RE: Project No. **143120-4, TMUA-W 16-43**
Mingo & Catfish Channel Improvements

ADDENDUM NO. 1

**ADDENDUM NO. 1
TO
PROJECT NO. 143120-4, TMUA-W 16-43
MINGO & CATFISH CHANNEL IMPROVEMENTS**

**ADDENDUM NO. 1
TO
MINGO & CATFISH CREEKS CHANNEL IMPROVEMENTS
PROJECT NO. 143120-4, TMUA-16-43**

RESIDENTIAL STORM CURB OPENING
CITY OF TULSA, OKL

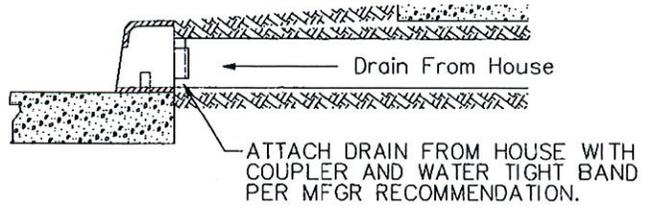
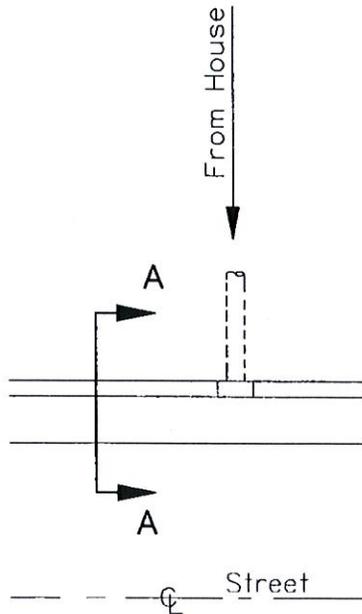
All re-established drains shall include a storm water curb opening as described in City of Tulsa Standard Drawing 758.

1. CONTRACTOR SHALL RECONNECT DRAINS FROM ADJACENT PROPER THROUGH THE CURB.
2. INSTALL R-3262-3 SERIES HEAVY STORM WATER CURB OPENING BY NEENAH OR APPROVED EQUAL
3. FIELD VERIFY SIZE AND LOCATION PRIOR TO PAVING OPERATIONS.
4. CONTRACTOR SHALL CAST INLET PLACE DURING CURB PRODUCTION "CUT IN" NOT ACCEPTED.
